REMARKS

OBJECTIONS TO THE DRAWINGS

FIG. 3A

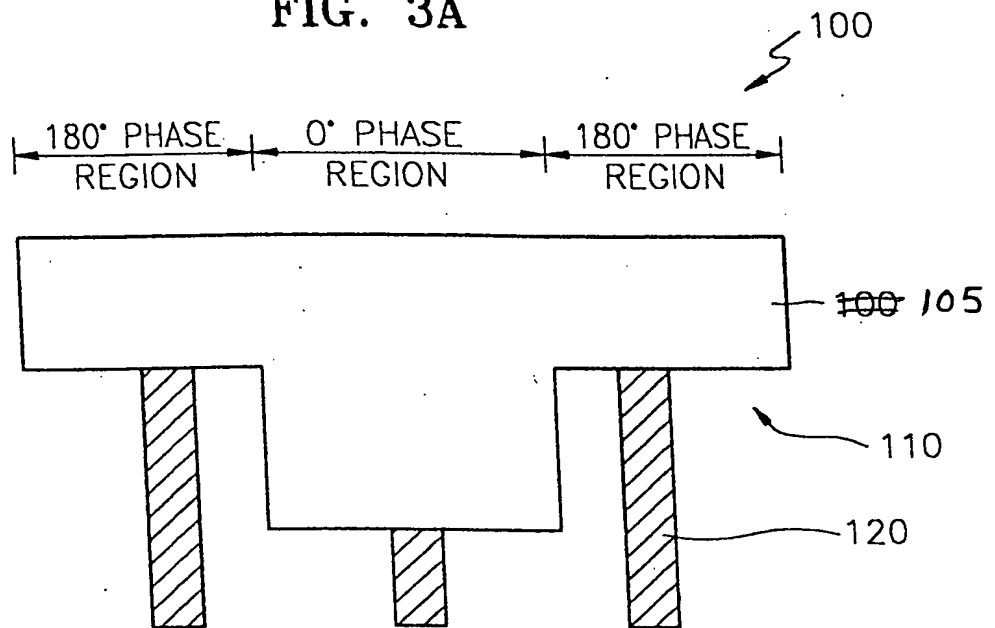
The objection that FIG. 3A should somehow be inverted is respectfully traversed, as Applicants are unaware of any rule which specifies a particular angle or viewpoint from which an object must be shown.

Please find attached to this paper, new drawings for FIGs. 1a-d, FIG. 3A, FIG. 4, and FIGS. 5A-5C, correcting minor informalities noted by the Examiner.

FIG. 4

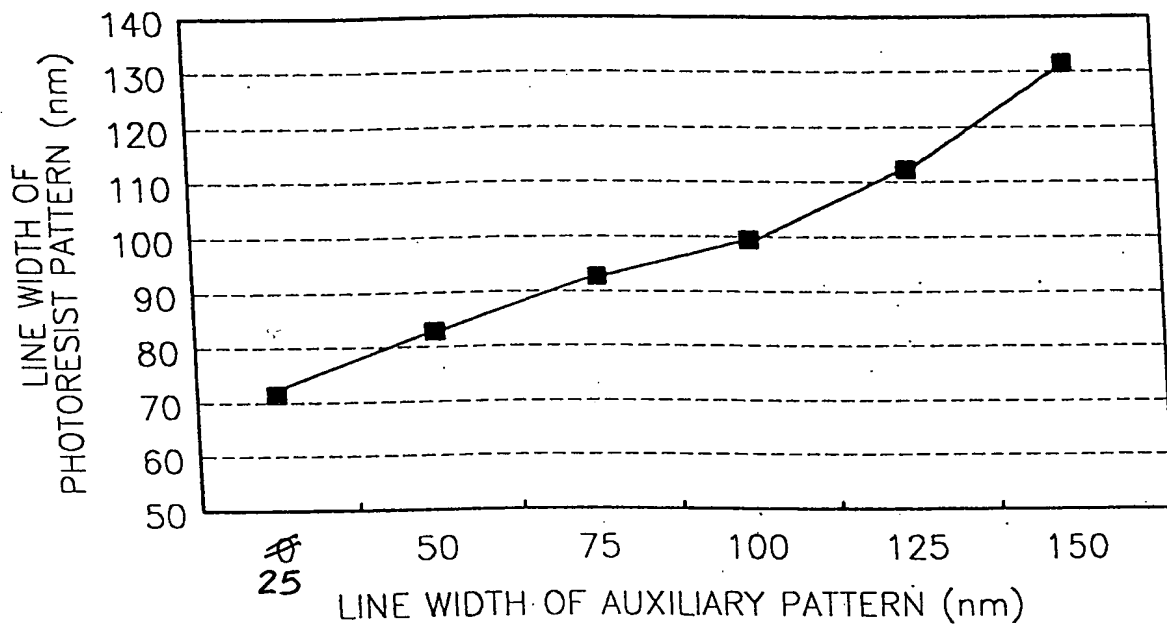
Applicants respectfully traverse the objections to FIG. 4 that: (1) FIG. 4 shows an apparently non-linear graph; and (2) FIG. 4 does not extend above 150 nm.

There is nothing that requires that FIG. 4 show a linear graph. The text in the specification cited by the Office Action is clearly permissive in nature ("may") as opposed to stating any exacting, rigorous requirement. Moreover, the graph in FIG. 4 actually does observe the stated relationship over the range of 25-125 nm. So FIG. 4 amplifies and expands upon the exemplary language in the specification, without being inconsistent therewith. Therefore, Applicants respectfully traverse this objection to FIG. 4.

Furthermore, there is no requirement that FIG. 4 plot any relationship for auxiliary pattern line widths above 150 nm. Indeed, the drawings would satisfy the requirements of 37 C.F.R. § 1.84(b) for claims 6 and 11 even if FIG. 4 was deleted in its entirety! That is, claims 6 and 11 include a feature pertaining to an auxiliary pattern, particularly, **a line width** of the auxiliary pattern. FIGs. 3A and 5C show the auxiliary pattern, including a line width of the auxiliary pattern, thereby satisfying the requirements of 37 C.F.R. § 1.84(b). Meanwhile, FIG. 4 does not show any auxiliary

pattern at all, and therefore certainly cannot possibly illustrate a line width of an auxiliary pattern! Instead, FIG. 4 shows a **graphical relationship** between a line width of an auxiliary pattern and a line width of a photoresist pattern. Now ***if*** claims 6 and 11 recited such a relationship, and if they recited that relationship over a range where the auxiliary pattern line width that exceeded 150nm, then the Examiner's objection **might** have merit. But that is not what is claimed here. Meanwhile, the features that actually *are* recited in claims 6 and 11 are shown in FIGs. 3A and 5C. Therefore, Applicants also respectfully traverse this objection to FIG. 4.
